PUBLIC INTEREST REVIEW FOR GROUND WATER APPLICATIONS

SUBJECT: Application G- 16668 Supersedes review of N/A
Date of Review(s)

A. **GENERAL INFORMATION:** Applicant's Name: Joseph and Lois Eckley County: Harney

A1. Applicant(s) seek(s) 14.0 cfs from ten well(s) in the Malheur Lake Basin,
 _____ subbasin Quad Map: Northeast Harney Lake

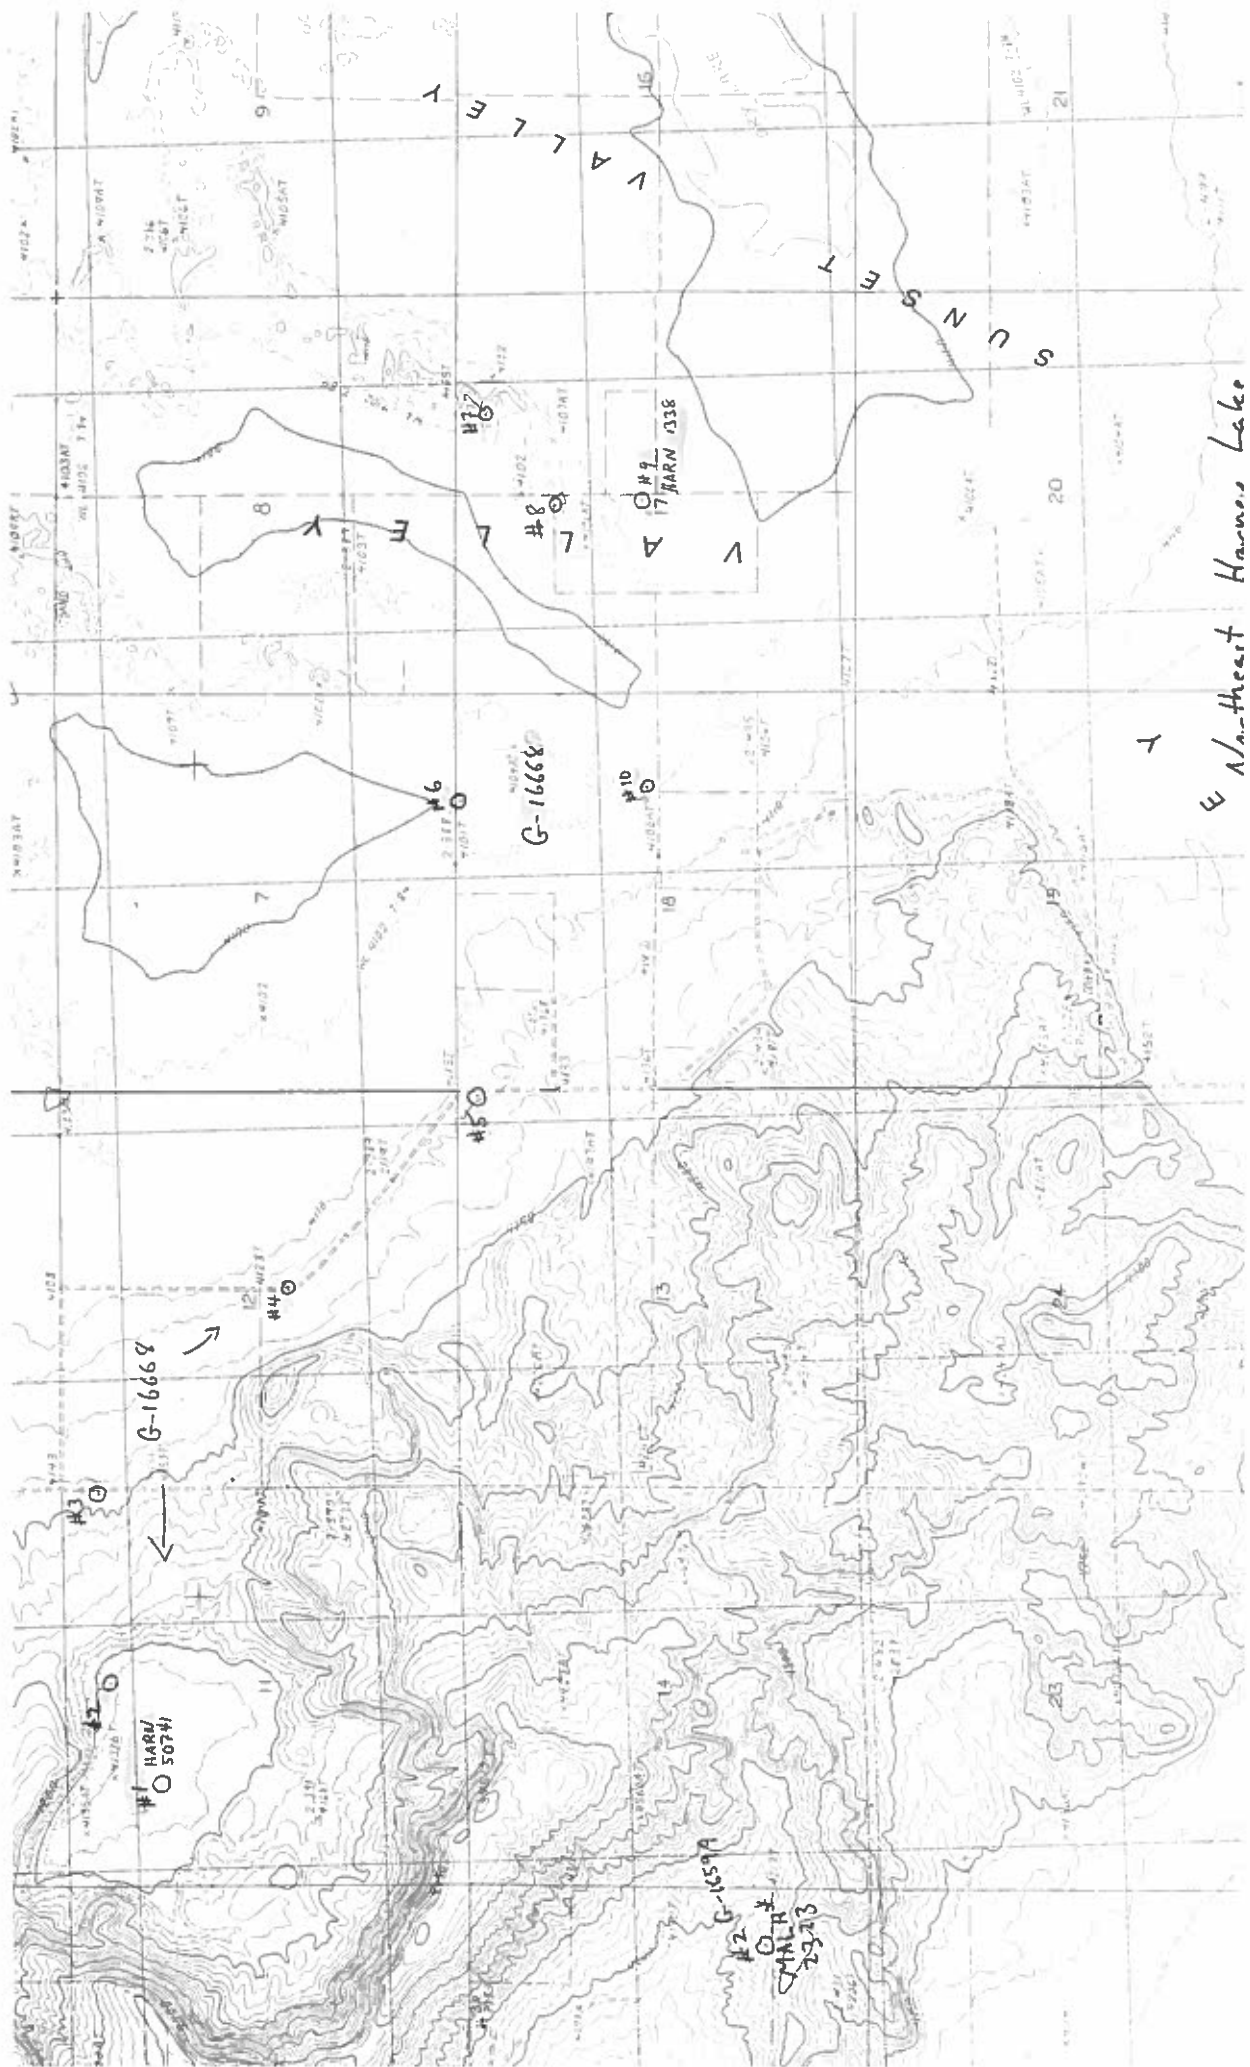
A4. **Comments:** Cinders are described as the water-bearing zone. HARN 50741 amended log shows liner sealed to 121'. No construction information provided for wells 7 and 8 (See recommendation at B3); elevations are estimated as 4103 and 4102 feet. Well 10 is proposed to be 100± feet deep; elevation estimated as 4102 feet. Both wells 1 and 9 case or seal off a shallow saline water-bearing zone. The proposed wells may need to do the same.

Basis for aquifer hydraulic connection evaluation: *Elevation from quad map (1983). It is generally accepted that Harney and Malheur Lakes are regional discharge areas for the ground-water system in the basin. I expect actual interference will likely be very diffuse.
